Site Development Plan, Environmental Sensitivities & Recommendations from the Aquatic Specialist (Confluent Environmental)

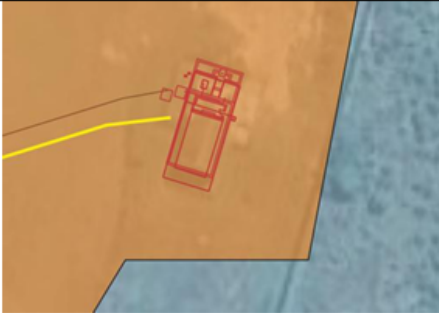
Image	Location	Description	Requirement for Further Consideration
	1. Western extent of Sandhoogte Road adjacent to natural drainage line and associated riparian zone.	The drainage line is on the northern, downslope side of the road. If sewer line placement can be on the upslope (cut side) of the road, then it will be located outside of the regulated area of the watercourse.	If the sewer line can be upgraded along the cut (upslope/southern) side of Sandhoogte Road then it will be located outside of the regulated area of the watercourse and will not require further assessment.

2. Upgrade section crosses a channelled but well vegetated outflow of stormwater under Lang St. with some wetland vegetation, connected to the EFZ (See Figure 20). 34° 3'5.53"S, 22°12'53.65"E	Stormwater outflow supports wetland and estuarine plants connected to the EFZ with the result that construction and maintenance must be carefully undertaken at this point.	Provided excavations can be undertaken without disturbance to the existing stormwater channel, and all material for and from the trenching is placed on the northern side of the trench, then the risk to the estuary is considered very low. No further assessment would be required.

3. Cricket field pump station to be upgraded or decommissioned (depending on Alternative 1a or 1b) is located close to the more natural edge of the EFZ. 34° 3'4.36"S, 22°12'59.50"E	The existing pump station is located 10m from the disturbed edge of the EFZ on entirely flat ground.	Provided activities can be restricted to the existing disturbance footprint of this area, the upgrade presents a very low risk to the EFZ and would not require further assessment. To mitigate the conceivable risk of leakage and overflow to the estuary, an emergency overflow reserve (tank), overflow alarms and concrete bunding should be included in the design.

4. Tennis courts pump station to be constructed based on Alternative 2 (includes decommissioning Cricket field pump station). To be constructed within the EFZ on a completely transformed area but adjacent to drains which lead to the estuary. 34° 3'1.15"S, 22°12'54.15"E	The location of the proposed pump station is 168m from the disturbed edge of the EFZ. Located further away from the natural edge of the EFZ than the cricket field pump station. However, a stormwater drain surrounds the site which leads directly to the estuary.	Although this site is located within the EFZ it is entirely transformed and lacks any features associated with estuarine habitat. The adjacent stormwater drain links directly to the estuary however, and for this reason, the PS should be designed with emergency overflow reserve (tank), overflow alarms and concrete bunding to prevent leakage to the drain. Access by vehicles from the main road is excellent.

<p>5. Eastern section of Lang St. which is adjacent to the natural edge of the EFZ (Figure 21).</p>	<p>No direct impacts expected, but indirect impacts associated with eroded material washing into the estuary from one large stormwater drain is possible (red arrow).</p>	<p>Provided the sewer line is located on the more developed (south-western) edge of the road then disturbance should be minimal. The stormwater outlet should be protected from silt/soil from entering the channel with the use of sandbags to demarcate the work area and to contain dirty water in the event of rainfall. If this potential impact can be effectively mitigated, then no further assessment is required.</p>
---	---	---	---
